**City of Gainesville
Department of Doing**

SUBJECT: DB-18-017 Oaks Preserve Design Plat – Resource Conservation Report

Figure 4: Pre-application Wetland and Urban Pond Data

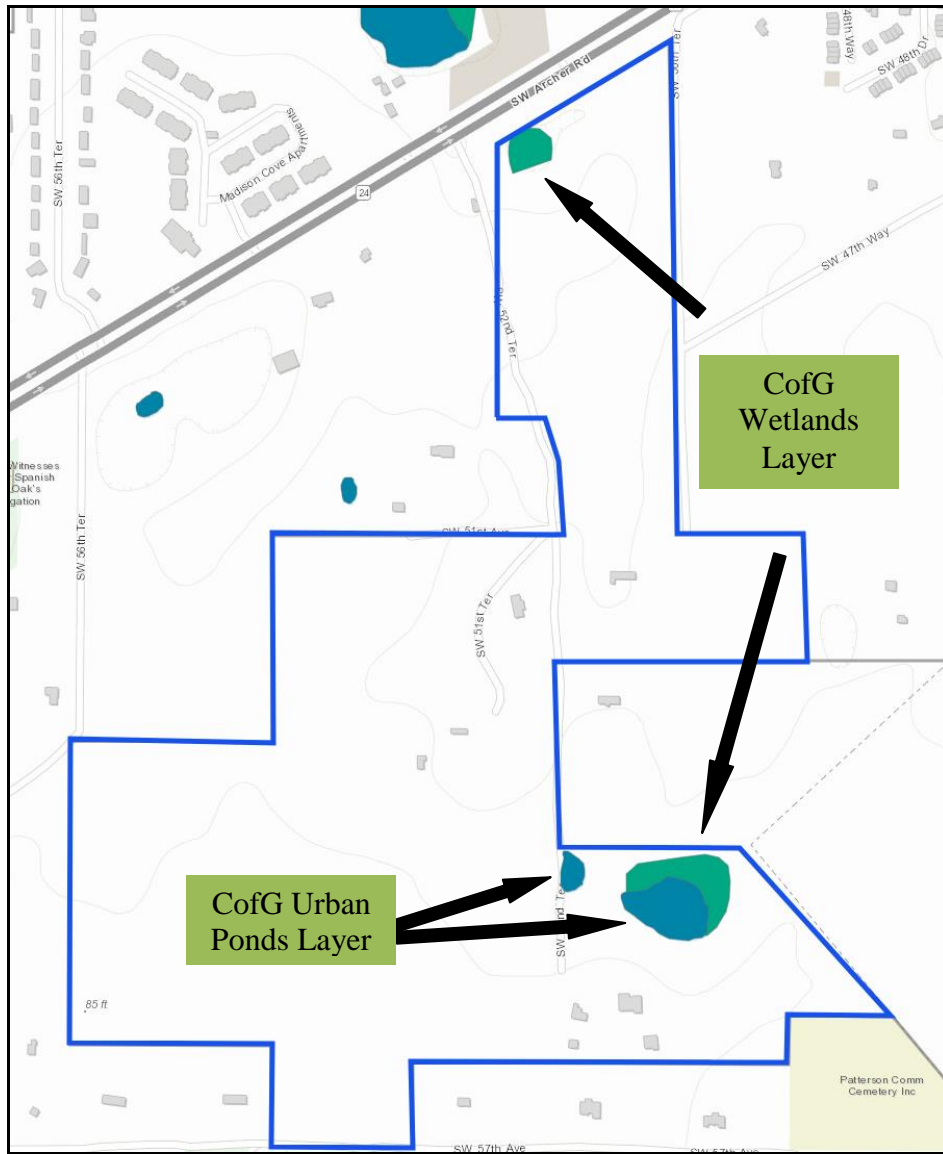
At the time of application City of Gainesville and Alachua County data indicated two wetland areas and two “urban ponds” (Fig. 4). However, the report submitted by Normandeau Associates identified four wetland areas occurring in the southern portion of the project site (Fig. 5) and did not include the northernmost “wetland.” C of G and Alachua County Environmental Protection Department staff conducted field verifications and concur with Normandeau’s findings. What is shown in C of G data as a “wetland” nearest SW Archer Road is actually a manmade depression with little to no ecological value. The most southeastern and largest wetland is a freshwater pond lined with Cypress, Oak, Cabbage Palm, Cat-tail, and Maidencane. Just to the west is the second largest wetland which is

Figure 6: Proposed Wetland Buffers

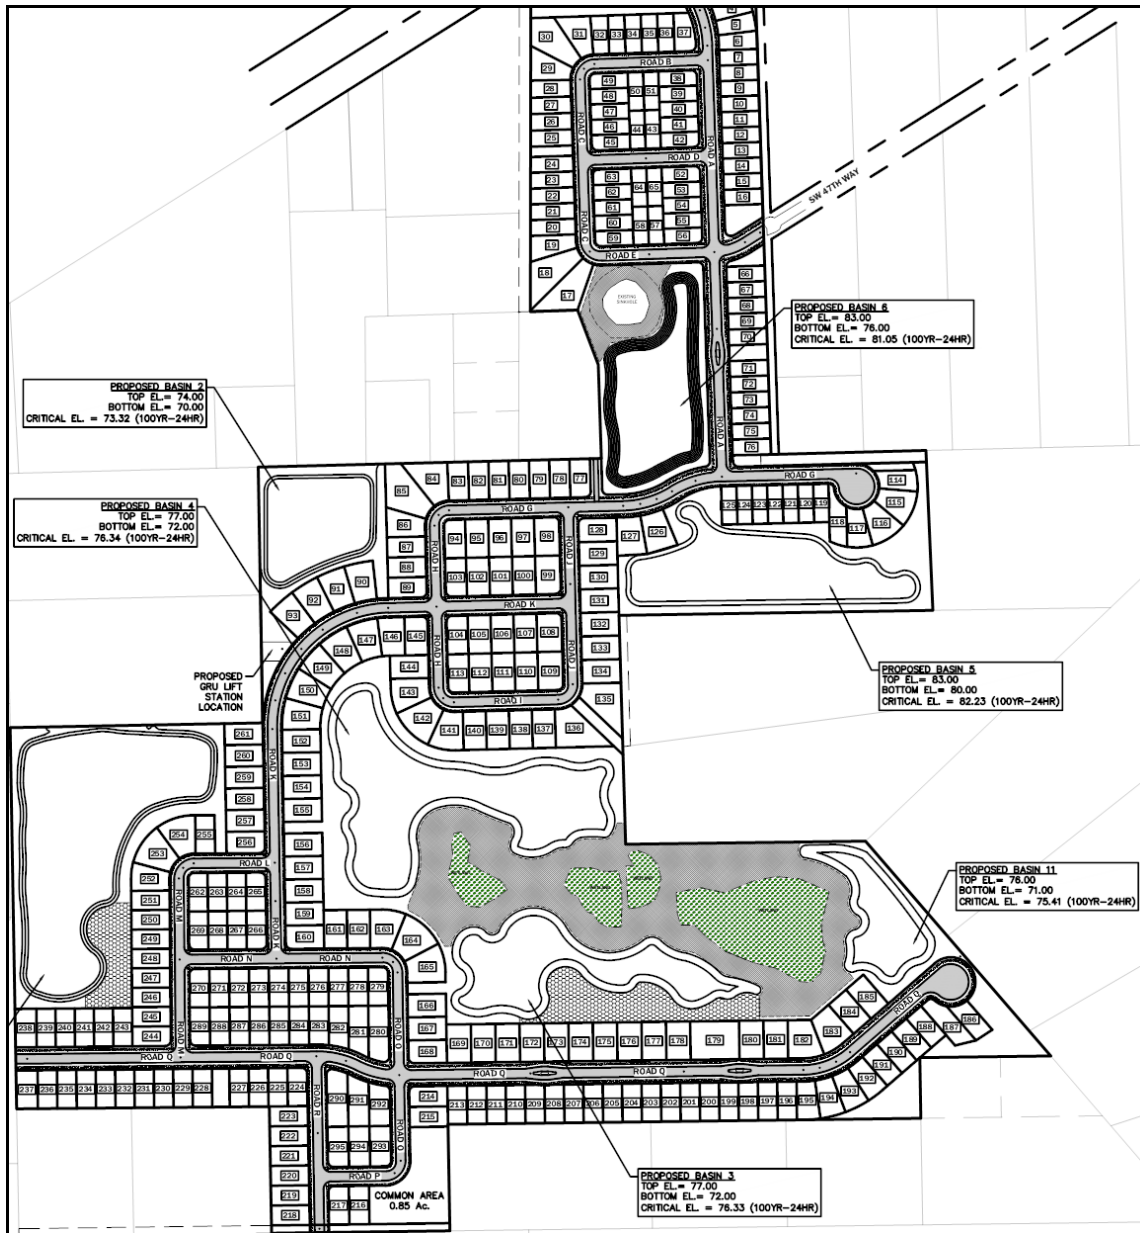
The proposed Design Plat shows a wetland buffer of a minimum of fifty feet and a maximum of seventy-five feet which significantly exceeds the City's minimum requirements (Fig. 6). In addition, much of the site's stormwater treatment is designed to be adjacent to the wetland buffers creating a larger connected open space and greater potential for supporting habitat restoration. In one such area stormwater facilities are proposed directly to the east of the wetland areas. The applicant has been encouraged to include a more "natural" connection to the Bear Hammock Strategic Ecosystem to establish and promote a larger interconnectivity between conservation areas. However, staff is aware of the various design challenges inherent on the site in regards to connectivity and is largely supportive of the proposed wetland buffer design.

Figure 7: Potential Sinkhole Features (circle shows non-significant feature)

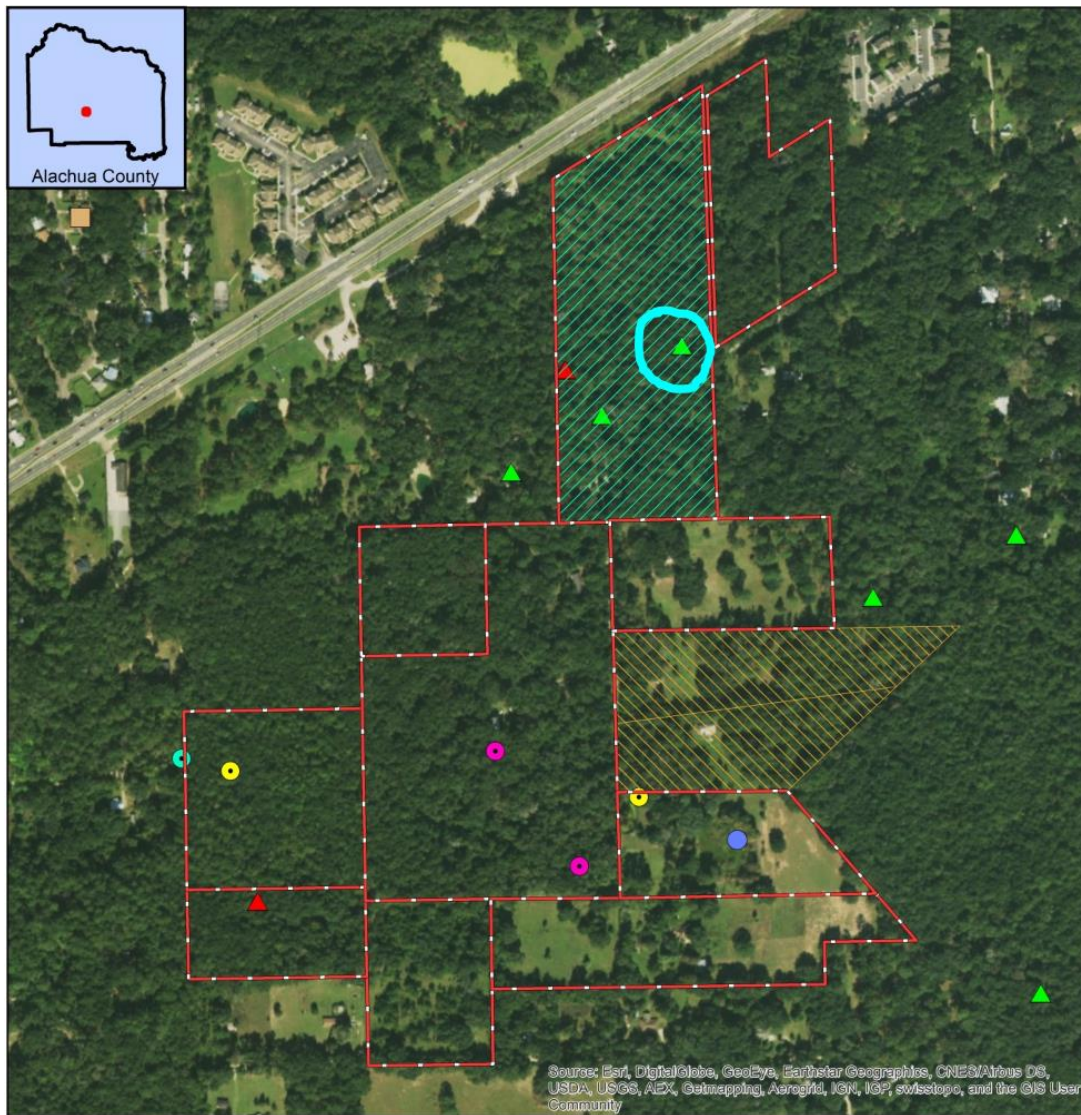
C of G and Alachua County did not have any data on existing sinkholes on the project site at the time of application. The Normandeau report identified four potential locations for sinkholes on the property based on existing topographic data (Fig. 7). Physical review of the site showed that two of these features were non-existent and two were clearly features (shown as red and green triangles in Figure 7). The westernmost of the two features was field verified as a sinkhole. The status of the eastern feature warranted further investigation by a geotechnical specialist.
